31 August 2022

School Infrastructure NSW
C/- Mace Australia
Level 17, 44 Market Street
Sydney, NSW 2000

RE: RESPONSE TO TRANSPORT COMMENTS ON MURWILLUMBAH EDUCATION CAMPUS

On-Street and Public Parking Survey Map and Results

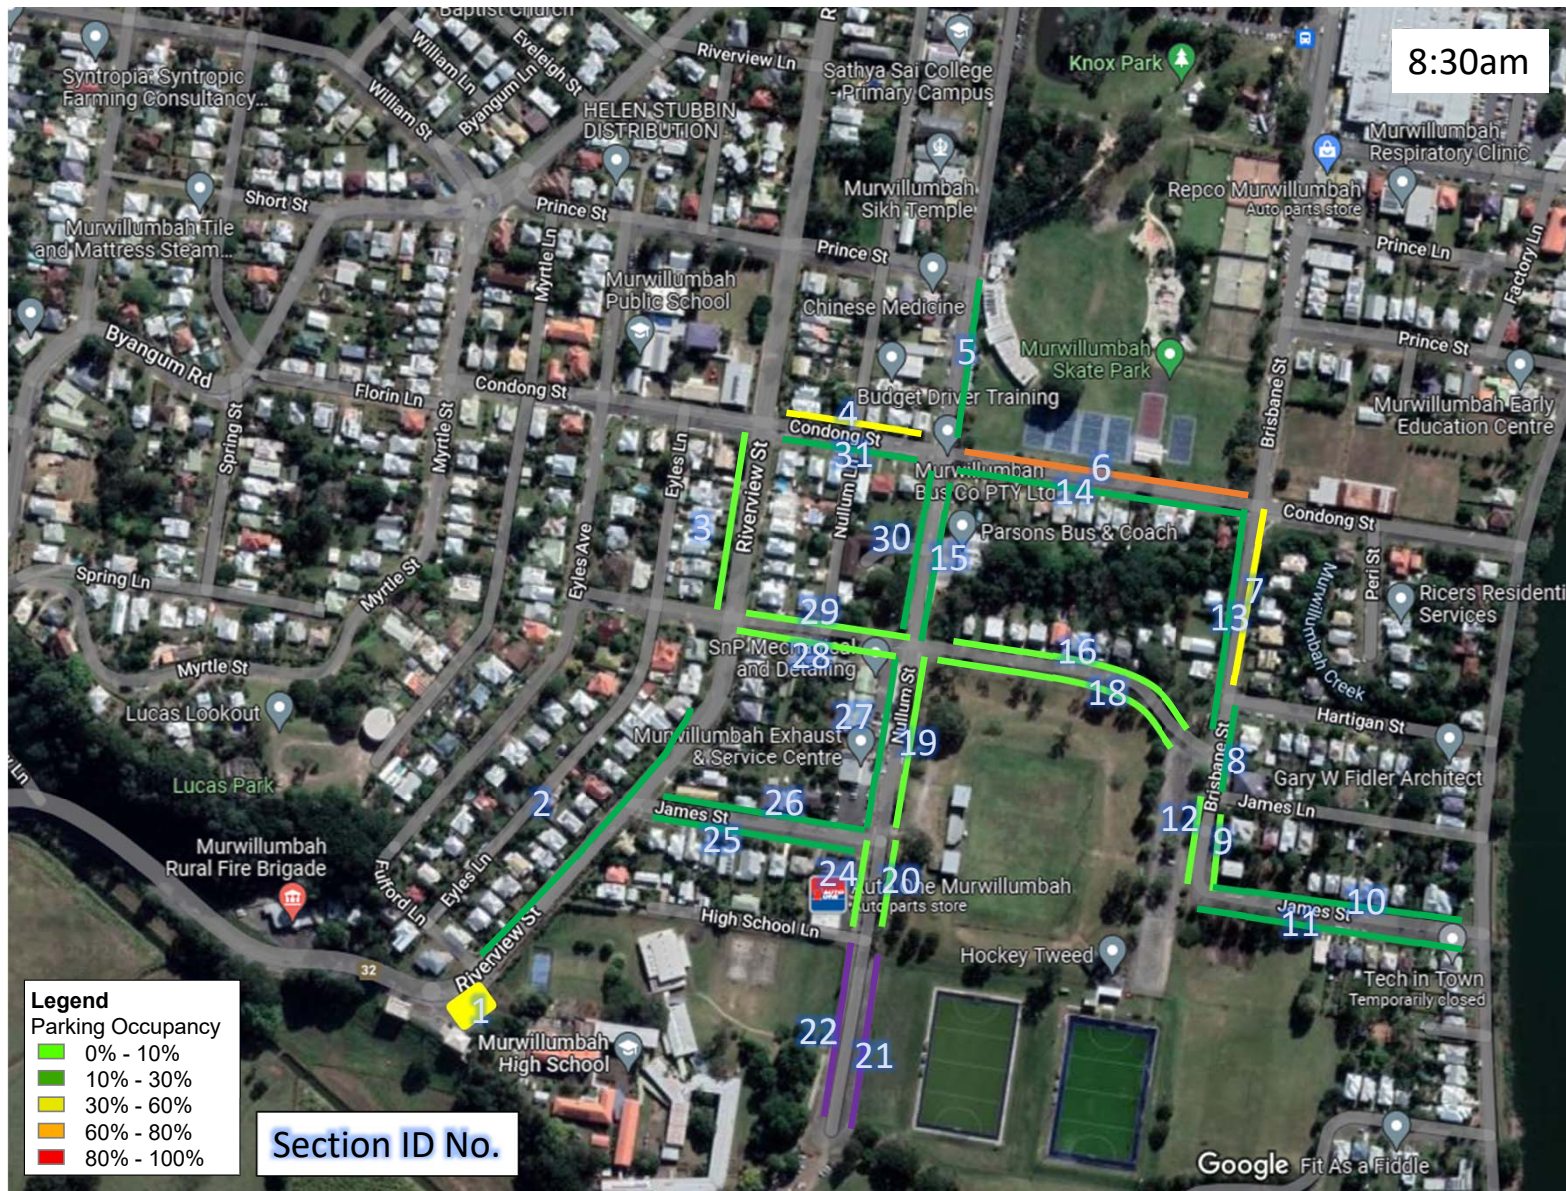
<i>c. The proposed parking provision is considered inadequate. There are only 161 spaces proposed on site. There is an estimated 168 staff (teaching/support) to be on site on any given day. In addition, a DoE regional office is proposed with 25 staff and storage required for 7 fleet vehicles. Using the provided data that 99% of Staff drive to work, the minimum car parking required is $(168 + 25) \times 0.99 + 7 = 199$ spaces just to cater for staff. While there is potential on street parking availability on Nullum Street of 48 spaces, these will be consumed by staff. Therefore, parents who wish to visit the school or students who are expected to drive (90 estimated) will park some distance away in front of residential properties and will result in parking compliance issues and resident amenity complaints to Council.</i>	It is important to note that the FTE numbers on which the calculations are based are for ultimate approval 'design capacity', however forecast projections for student population do not actually reach full capacity meaning the full quantum of FTE allocation is not expected to be realised. To supplement the parking assessment to date, a review of public and on-street parking occupancy has been undertaken for the surrounding streets and parking areas. The detail of the results is provided in Attachment A. In summary: ■ A total estimated 404 on-street car parking spaces were surveyed within the surrounding catchment. - During peak times, available on-street parking supply will reduce to 382 spaces based on Nullum Street bus zone times (8:30-9:30am and 3:00-4:00pm) ■ A maximum of 74 parking spaces were occupied (which occurred at 10:30am) leaving a total of 322 spaces of available capacity within the surrounding streets. Based on the concentration of higher parking demands around Condong Street and Nullum Street (North of Condong Street) at this time, the demands in that particular area were attributed to the nearby community centre. During this time, on-street parking was rare and freely accessible across all other streets ■ During the school peak times (8:30am and 2:30pm) there are only 66 parking spaces occupied in the surveyed area, meaning there is currently 316 on-street spaces available. ■ Between 3:00-3:30pm, when school peak pick up occurs there are only 66 to 61 spaces occupied leaving at least 316 spaces available. The results demonstrate that there is significant on-street parking capacity surrounding the MEC site. Parking demands (even with the inclusion of the existing MHS) remain low throughout the school day. As agreed with Council officers at the meeting held on the 29th July, the parking survey results are

<u>Car parking shortfall and impact on adjacent Council managed facilities.</u> ...Council is concerned that the overflow car parking demand (60-90 cars per day) generated from the school development will unacceptably impact nearby public facilities. Council as facility-owner does not support the resultant burden this will have on the public facilities in the area, particularly without the development financially contributing...	As noted in the earlier response to parking items there is sufficient on-street car parking capacity to accommodate for any overflow parking demands. As such, the school would not be reliant on use of parking associated with the adjacent Council sports facilities. School Travel Plan measures and associated communication collateral can be specific to discourage use of this parking area such that there is no burden on this public facility. Regarding the potential use of council assets, this type of shared parking operation is also consistent with the existing operations as well as various other sports precincts across the Tweed Shire adjacent to schools.

Item	Response
	representative of the existing operations around the MHS, inclusive of existing MHS demands. Further to this, the parking surveys confirm that there is currently no adverse parking issues (to safety, traffic efficiency or amenity) surrounding the MEC site. Therefore, the expected additional parking demands associated with the MEC can be adequately accommodated within the precinct and will not result in exacerbation of any safety, efficiency, or amenity impacts. The proposal seeks to maximise parking on-site for staff, while also considering the existing established MHS operations, its relationship with its surrounds, operational parking needs for the school, as well as accommodating and promoting other travel modes over time. The ability to accommodate additional parking on-site is limited without compromising safety or other facilities within the school such as reducing available play space. Further to this, the installation of a KnD facility on-site is directly aimed at reducing parking demands associated with conventional parking layouts. While some overflow parking may occur to surrounding streets, this peak period operation is not unexpected for schools or community facilities as represented by Council's DCP rates. In addition, the site incorporates the established high school (MHS) and some level of parking activity within the surrounding area is well within the community's reasonable expectations.

<i>Parking demand, including overflow parking and parking at event times</i>	A total of 161 staff parking spaces are provided on-site. This provision is practical maximum on-site parking supply based on available space, while balancing the need for other school facilities (such as available play space) and adequate separation of student areas from on-site vehicle traffic. In addition to on-site parking there are a total estimated 404 on-street car parking spaces within a walkable distance of the MEC. During peak times school times available on-street parking supply will reduce to 382 spaces based on Nullum Street bus zone times (8:30-9:30am and 3:00-4:00pm) A maximum of 74 parking spaces were occupied (at 10:30am) leaving 322 spaces of available capacity. In the school peak times (8:30am and 2:30pm) there are only 66 parking spaces occupied in the

Item	Response
	surveyed area, meaning there is currently 316 on-street spaces available during school peaks in the wider precinct. The results demonstrate that there is significant on-street parking capacity surrounding the MEC site and parking demands (even with the inclusion of the existing MHS) remain low throughout the school day. Regarding school event times this above referred parking supply will be available and the school would seek to take a coordinated approach with Council to manage event times to limit potential for events at the school overlapping with any major sporting activities at the nearby sporting fields. This factor is no different to the existing and established operation of the existing MHS.
